POLARIS[®] TECHNICAL SERVICE BULLETIN

Bulletin Number: L-17-02-A

SUBJECT: 2017 GEM EPS BOLT INSPECTION

Figure 1

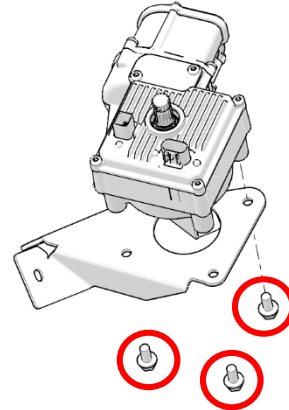
Polaris has found that a limited number of EPS-equipped vehicles were manufactured with bolts that have the incorrect thread pitch. These bolts mount the EPS module to its mounting bracket. These incorrect bolts damage the EPS unit as well as the bolts themselves. Any unit with incorrect bolts will require replacement of the bolts and the EPS unit. These bolts can be identified by their color; the correct bolts are an olive drab finish while the incorrect bolt is a yellow chromate finish.

The bolts in question are circled, which can be viewed in Figure 1.

INCORRECT
(Yellow Chromate Finish)

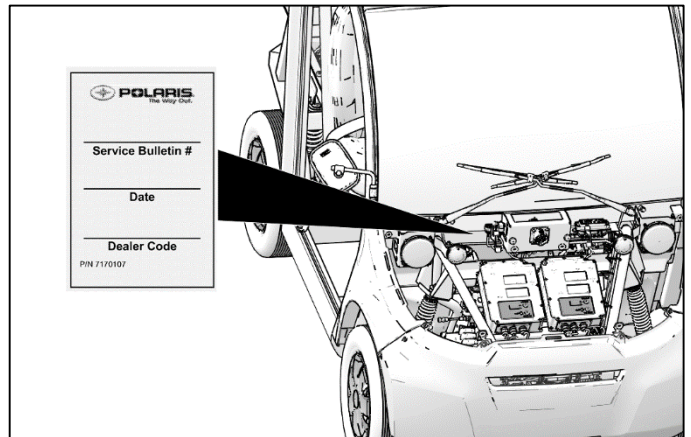
10. Inspect EPS bolt color while being underneath EPS unit and looking upward.

11. If the fasteners are an olive drab finish then no repair is necessary, reinstall dash components by reversing the order of steps 1-9. Install the bulletin completion decal on the frame, next to the Digital Wrench connector. File bulletin L-17-02-A.

12. If the EPS fasteners have a yellow chromate finish proceed with step 13.
